Form 3160-5 (June 2019)	UNITED STATES DEPARTMENT OF THE INTERIOR BUREAU OF LAND MANAGEMENT	FORM APPROVED OMB No. 1004-0137 Expires: October 31, 2021
SUNDRY NOTICES AND REPORTS ON WELLS <i>Do not use this form for proposals to drill or to re-enter an abandoned well. Use Form 3160-3 (APD) for such proposals.</i>		5. Lease Serial No. NMNM118726
		6. If Indian, Allottee or Tribe Name

Antietam 9 Fed Com 301H (FKA 211H) API #: 30-025-52252

EOG respectfully requests an amendment to our approved APD for this well to reflect the following changes:

Revised Permit Information 11/02/2023:

WELL LOCATION AND ACREAGE DEDICATION PLAT

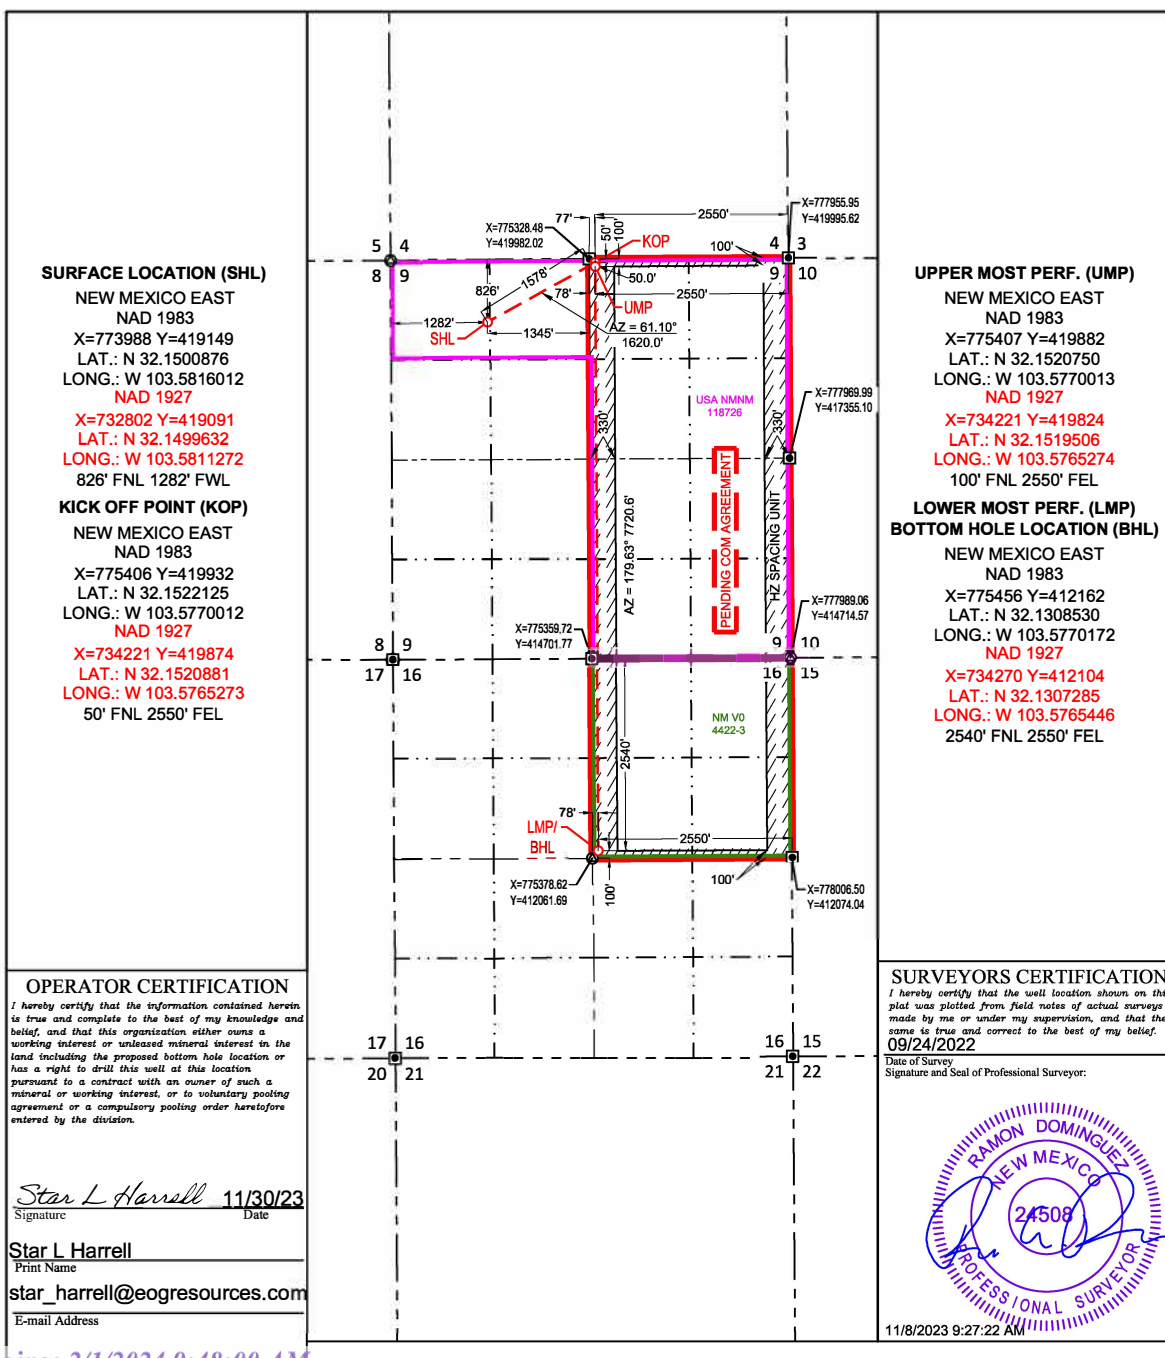
Change BHL from T-25-S, R-33-E, Sec 16, 2540' FNL, 1040' FWL, Lea Co., NM, to T-25-S, R-33-E, Sec 16, 2540' FNL, 2550' FWL, Lea Co., N.M.

UL or lot no.	Section	Township	Range	Lot Idn	Feet from the	North/South line	Feet from the	East/West line	County
G	16	25-S	33-E	-	2540'	NORTH	2550'	EAST	LEA

Dedicated Acres	Joint or Infill	Consolidated Code	Order No.
480.00			PENDING COM AGREEMENT

Revised Wellbore A:

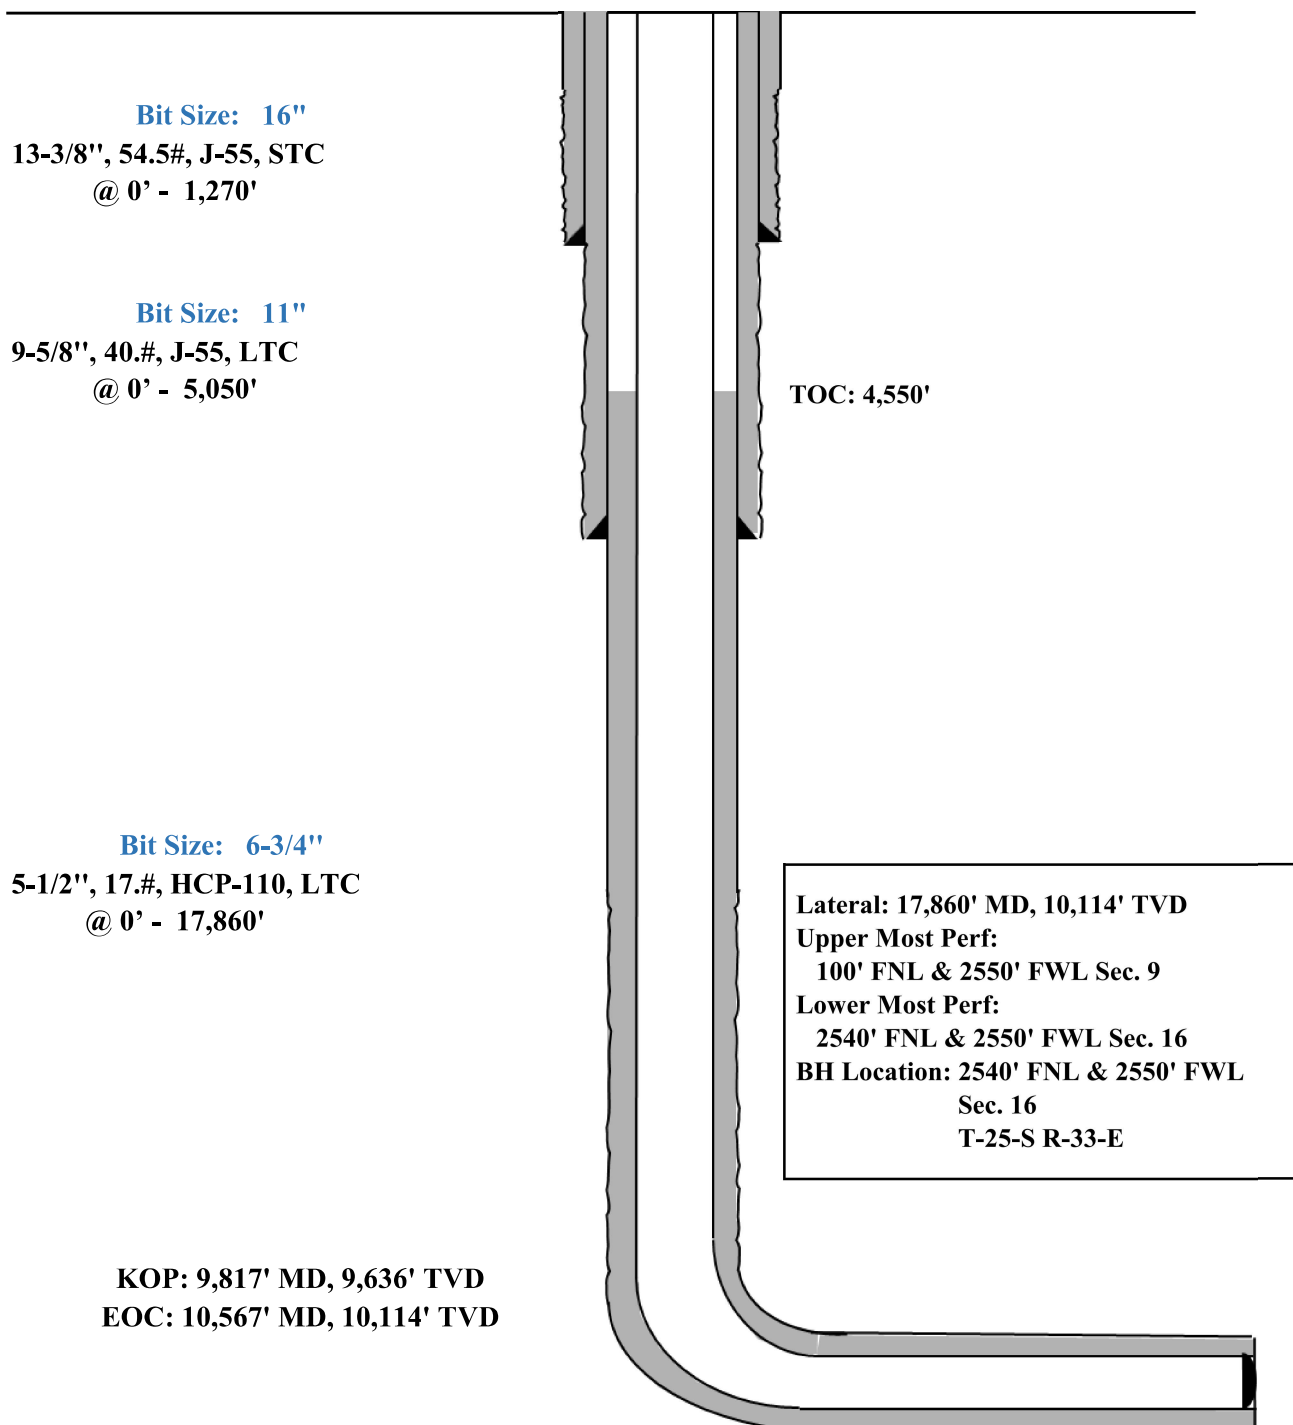
Update casing and cement program to current design.

Casing Program A:

Hole Size	Interval MD		Interval TVD		Csg OD	Weight	Grade	Conn
	From (ft)	To (ft)	From (ft)	To (ft)				
16"	0	1,270	0	1,270	13-3/8"	54.5#	J-55	STC
11"	0	5,241	0	5,050	9-5/8"	40#	J-55	LTC
6-3/4"	0	17,860	0	10,114	5-1/2"	17#	HCP-110	LTC

Revised Wellbore B:

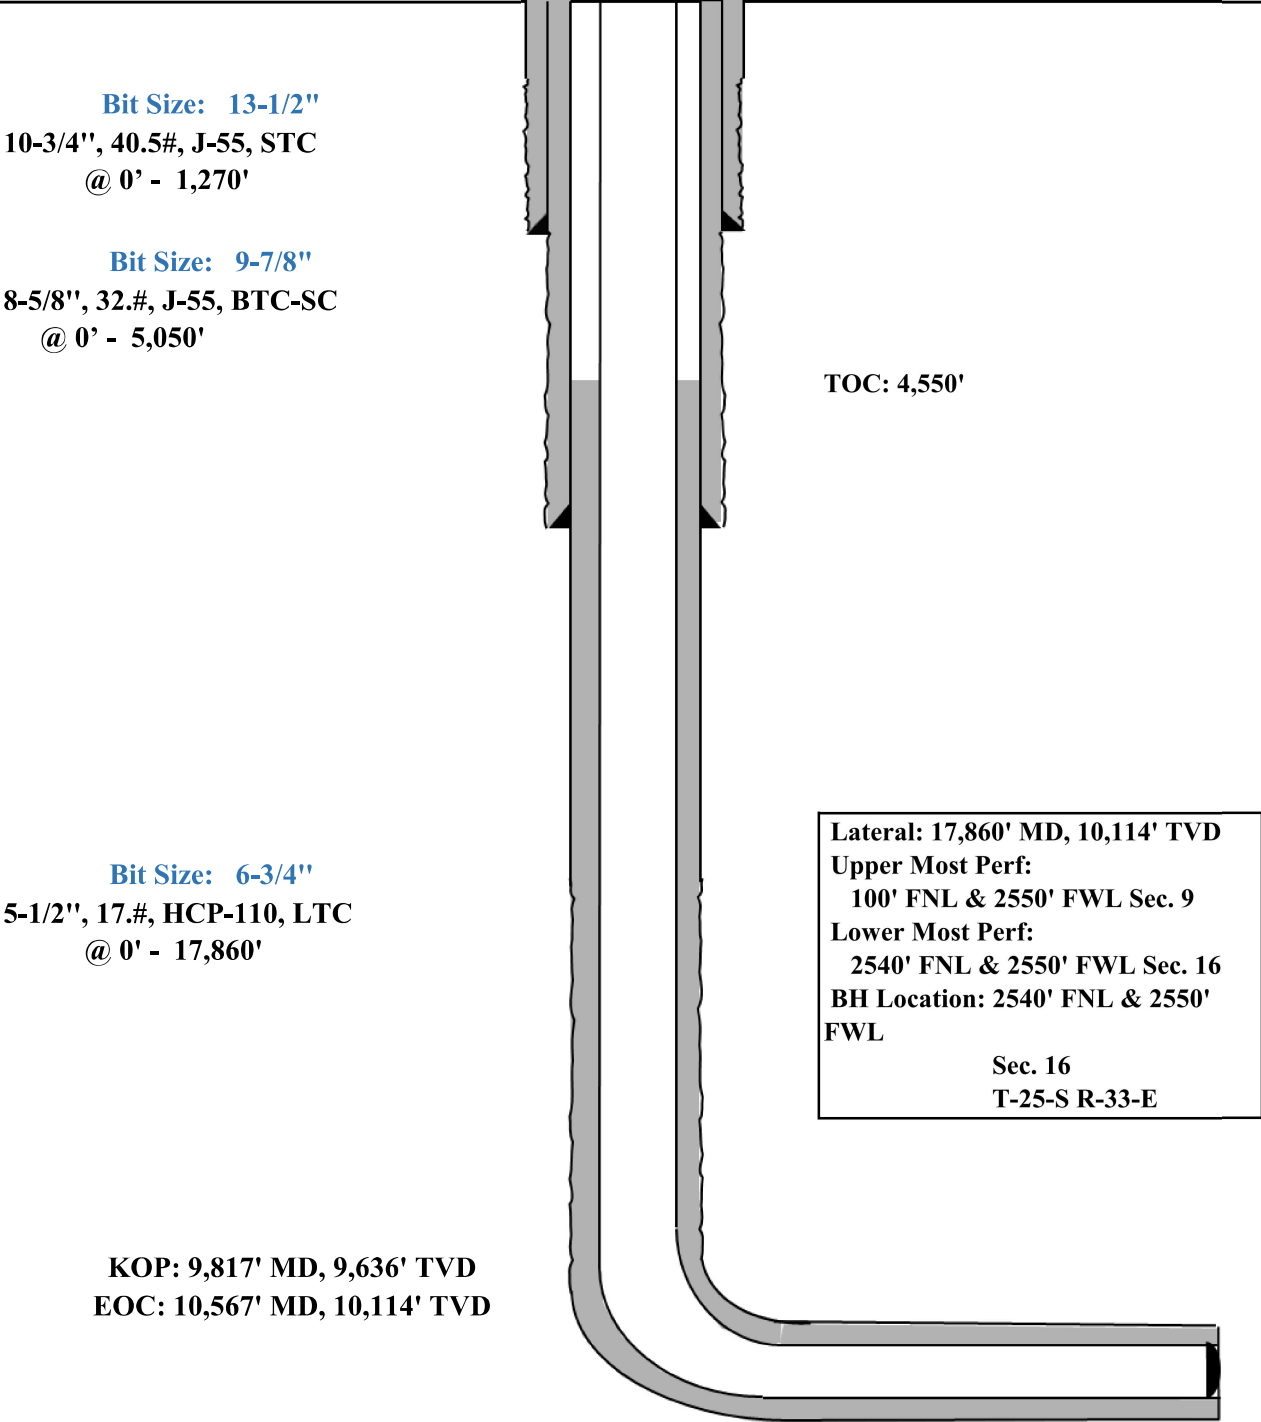
Casing Program B:

Hole Size	Interval MD		Interval TVD		Csg OD	Weight	Grade	Conn
	From (ft)	To (ft)	From (ft)	To (ft)				
13-1/2"	0	1,270	0	1,270	10-3/4"	40.5#	J-55	STC
9-7/8"	0	5,241	0	5,050	8-5/8"	32#	J-55	BTC-SC
6-3/4"	0	17,860	0	10,114	5-1/2"	17#	HCP-110	LTC
